Variation No. 1 to South Dublin County Development Plan 2022- 2028: Clondalkin Local Planning Framework

Chief Executive's Report on
Submissions/Observations
Received on the Material
Alterations to Proposed
Variation 1 to the County
Development Plan 2022-2028

13th February 2026

Section 8.7, Page 104, Figure 8.32

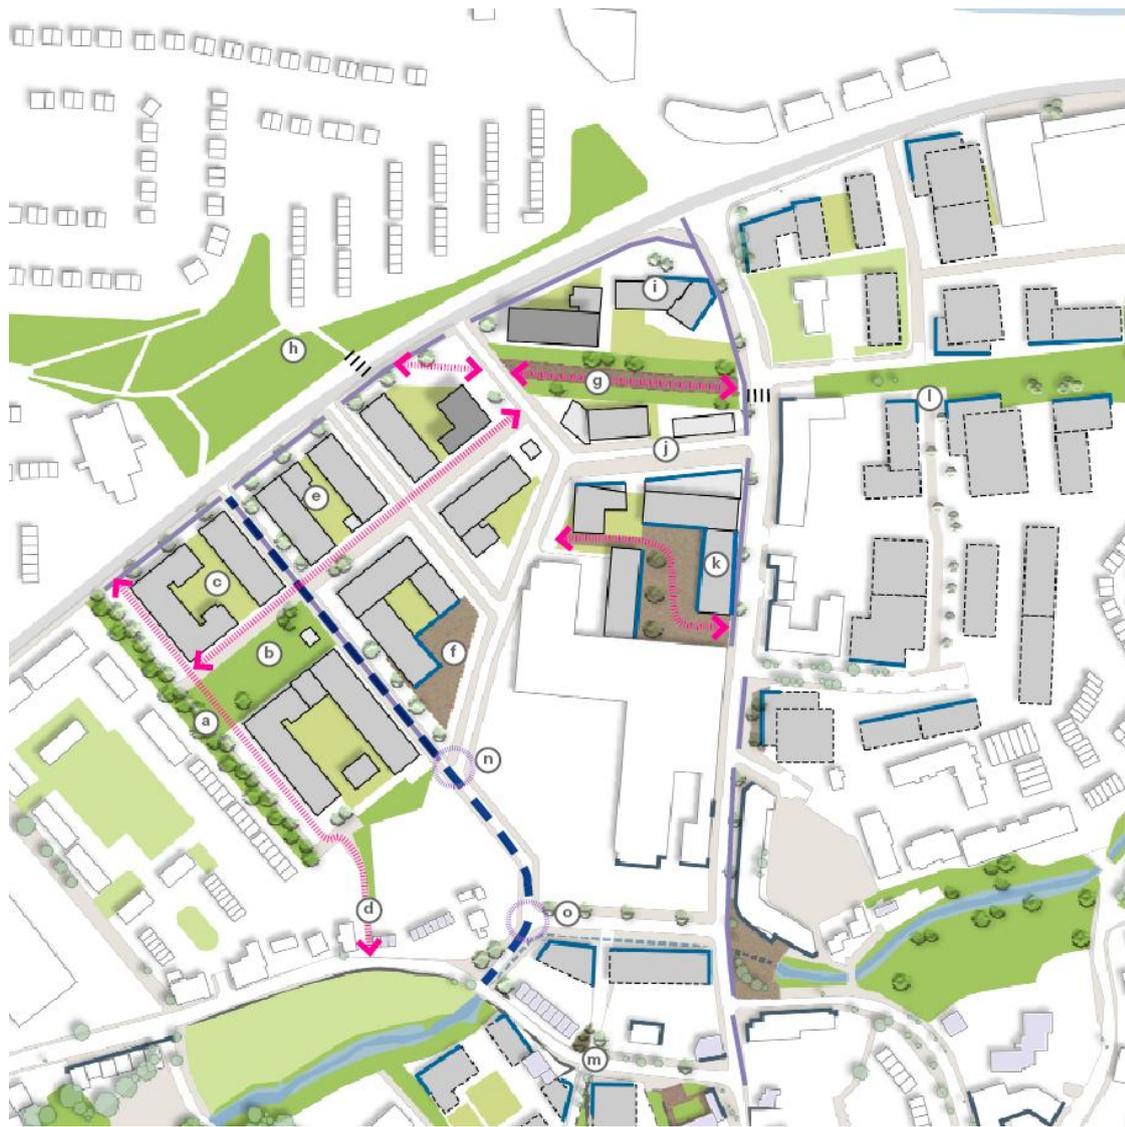
<p><u>SD-C396-5</u> <u>National Transport Authority</u></p>	<p>Submission Summary: The NTA are supportive of MA25 which amends Figure 8.32 to remove reference to vehicle movement and illustrate clearly the long term high capacity public transport route as identified in the CDP. MA25 also includes the identification of permeability links between the Ninth Lock Framework Site and the Mill Centre site.</p> <p>CE Response: The content of the submission is noted and welcomed.</p>
<p><u>SD-C396-12</u> <u>Thornton O'Connor Town Planning</u></p>	<p>Submission Summary: The proposed submission has been submitted by Thornton O'Connor Town Planning on behalf of ARP 4.3 Sustainable Communities (Ireland) Fund, in relation to lands located at the Ninth Lock Framework Site and Material Alteration 25.</p> <p>A large extent of the lands within the Ninth Lock Framework Site are owned by the submitter's client.</p> <p>The submission states that it is noted that the movement parameters for the site (page 101 of the Draft Clondalkin LPF) have not been updated to reflect the changes listed under</p>

The submission also notes the Ninth Lock Framework Site is subject to a number of design parameters which were altered under MA25, including permeability routes, active movement routes, vehicular connections, etc. As there is no certainty at this stage that adjacent landowners will agree to the inclusion of their land as part of any future development on the submitters land, their ability to deliver a scheme that precisely adheres to the Clondalkin LPF is restricted. The submission requests that the following language be included within the Ninth Lock Framework site section of the plan as follows:

The map and key are indicative only and intended to illustrate the broad development principles for the area. The precise layout, alignment and delivery of routes, connections and infrastructure may be subject to change at planning application stage, having regard to land ownership, technical constraints and detailed design, provided the overall objectives of the Framework Site are met.

<p>CE Response:</p> <p>In respect of the parameters referred to, it is noted that the wording of the parameters in the LPF facilitates options for the future servicing of the Mill Shopping Centre from the New Nangor Road through the Ninth Lock Framework Site thereby reducing the need for commercial traffic to access the service area exclusively from the Ninth Lock Road. It is not considered that the parameter as currently worded would prejudice the future development of any lands or wider movement strategies. It would be premature at this point to specify how that traffic would access the wider network through the Framework Site.</p> <p>In relation to the issue around proposed amended wording it is noted that the preparation of Framework Plans for large scale potential development sites within the LPF area is one of the key requirements arising from the decision of the Council to prepare a statutory plan for the Clondalkin Area. The purpose is clearly set out in the document with parameters and direction provided in relation to any potential future development of these lands. It is considered that the parameters and guidance set out in the Variation (LPF) are appropriate in terms of the need for the LPF to provide general direction on the Urban Design approach which should be taken in respect of the future development of this site.</p>

<p>CE Recommendation:</p> <p>It is recommended that the Proposed Material Alteration MA25 to Variation No. 1 be adopted without modification.</p>
